Drawing Title: **Proposed North West Elevation**

Project Name: **Haverstock Hill, Camden**

Project Ref: HHCAM -PWA-00 - ZZ -DR-A-0223 -G4

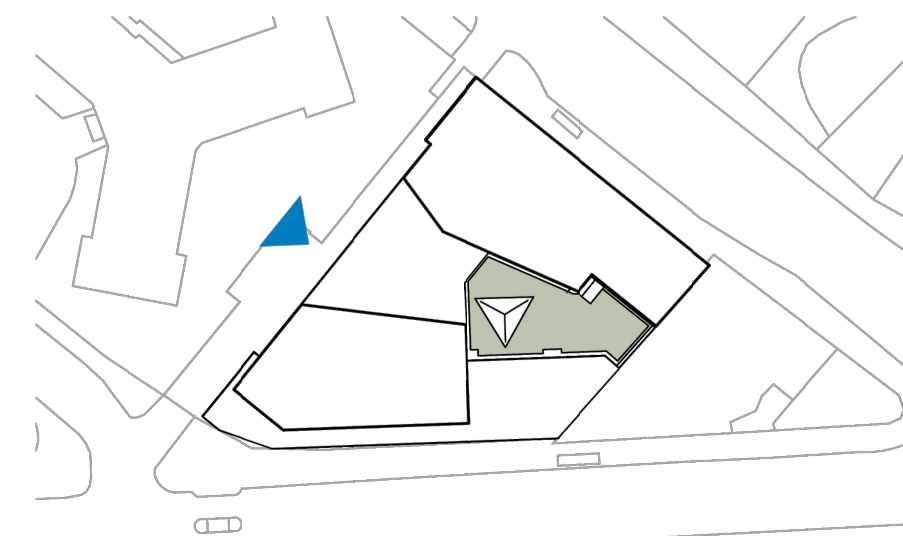
KEY AMENDMENTS

1. Balcony set back from curved windows which allows clear views in and out, unobscured by balcony railings.
2. Balcony width increased to improve the amenity and outlook.
3. Balcony and window arrangement amended to match the architectural language at the corner on Adelaide Road. Balcony improved, corner balcony post removed, enhanced internal apartment space to the corner. Windows added to 5th and 6th floor to provide access to the balcony and allow light into the space. Ground floor window moved around the corner for more privacy.
4. External covered space removed and incorporated into the apartment.
